Ref: FCC Class II Permissive change for FCC ID: ZPNVS60U029

Applicant: CUB ELECPARTS INC.

### Attachment\_ Description of the adjustments

#### 1. 電池更換成新廠商

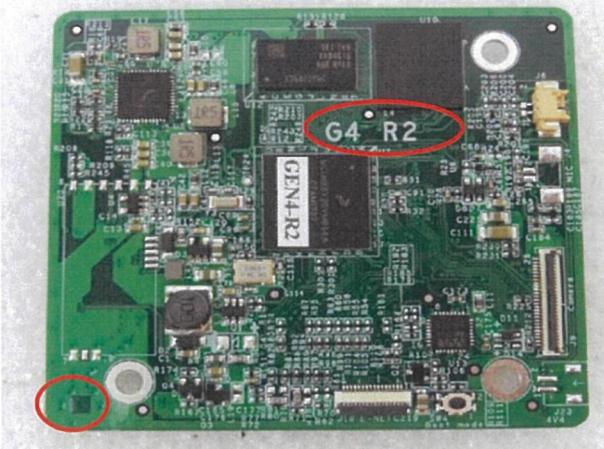
New battery manufacturer

#### 2. OS 版因應製成需求做進版，所以更換天線位置

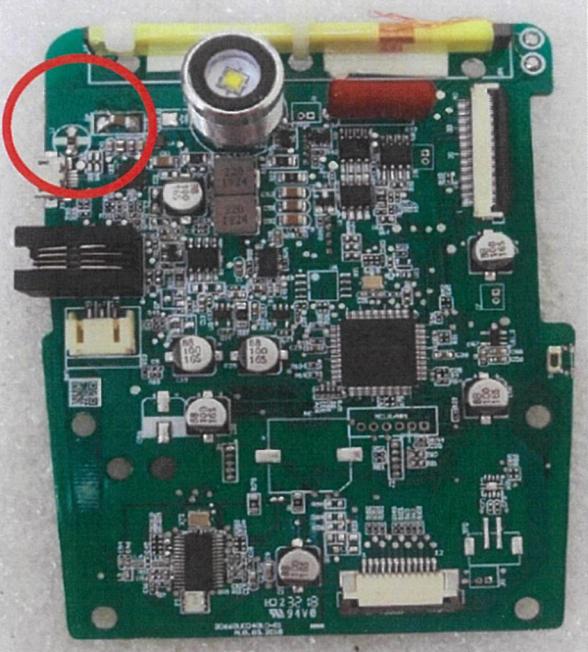
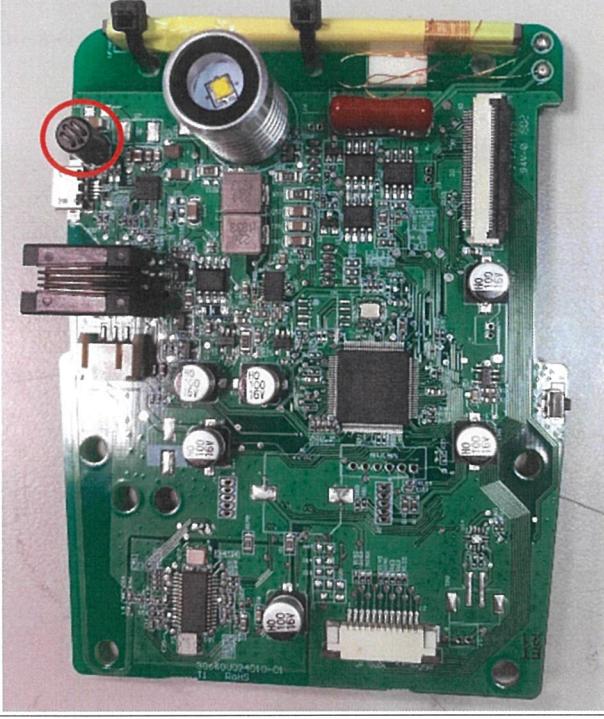
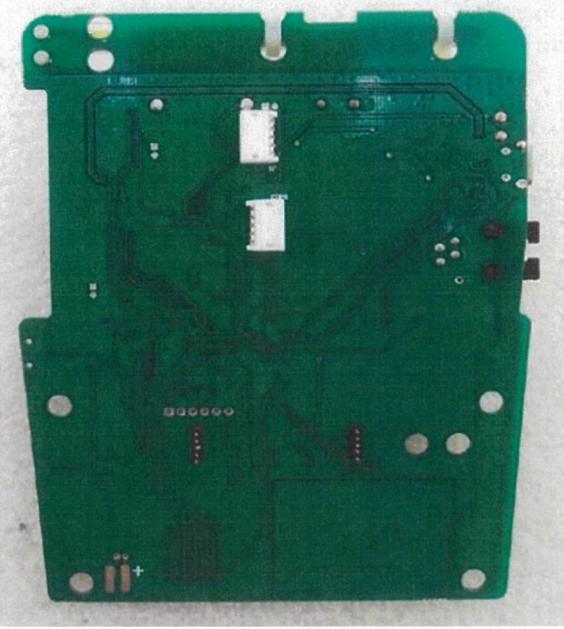
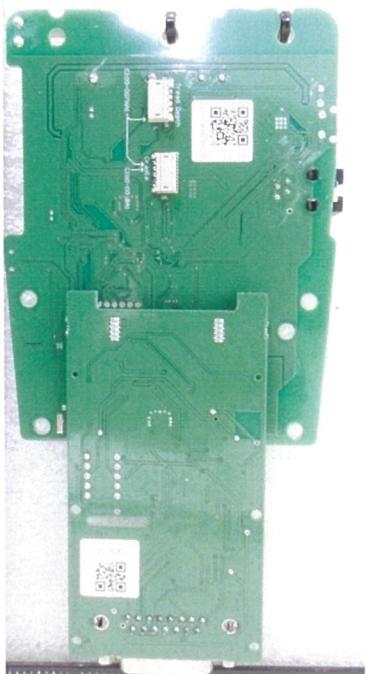
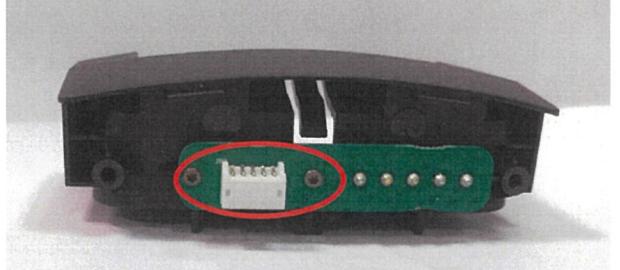
OS board is updated based on the production requirements. The antenna location is changed.

3. 主板更換電容位置&還有增加 ESD 保護元件

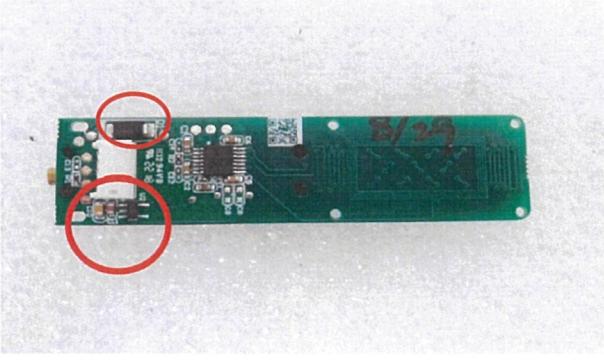
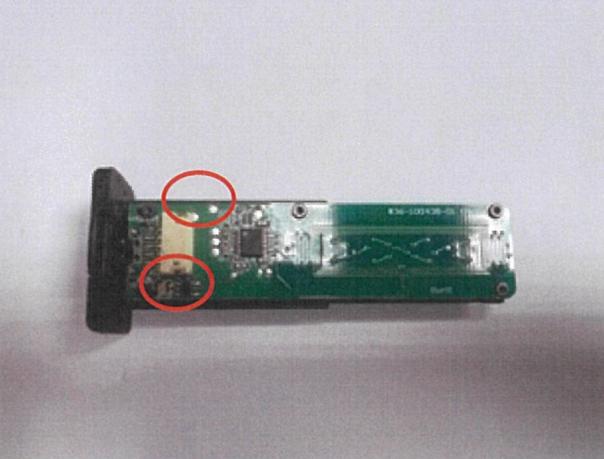
Capacitor's location is changed and additional ESD protective units are added on the main board.

4. 製成改鎖螺絲

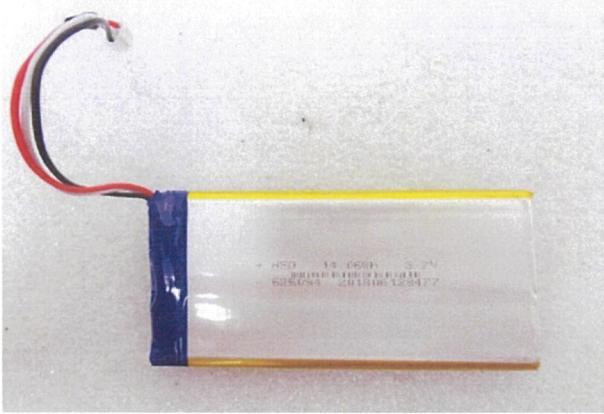
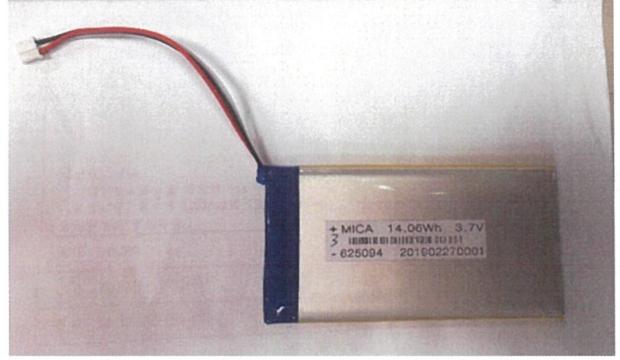
Manufacture assembly method is changed into screw fixation.

5. 因應工程要求修改連接器(SMD)，有更動元件位置

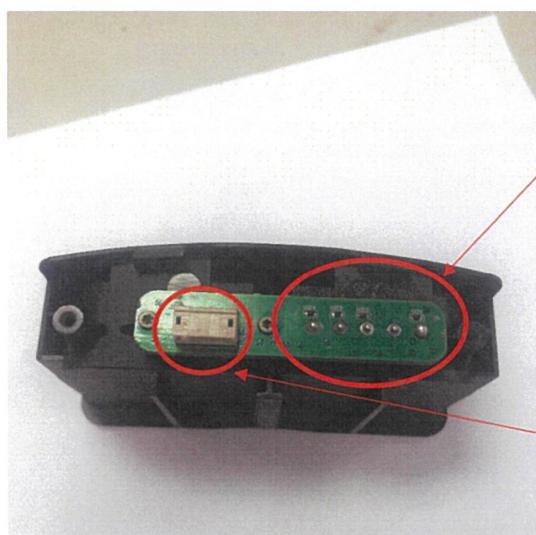
Based on the manufacture requirements, the components are changed from DIP to SMD.

## 7. Cradle PCB 差異

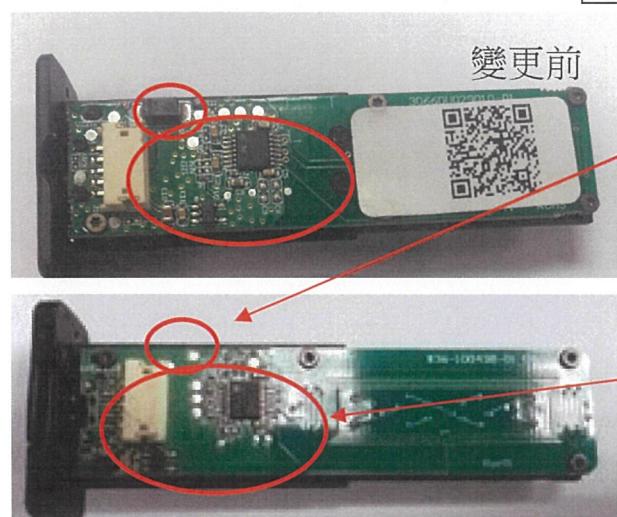
4 additional ESD protective units are added next to the 5 PIN

The 5 PIN connector can be changed into SMD so that only programming probes are required to be welded when the PCBA is ready.
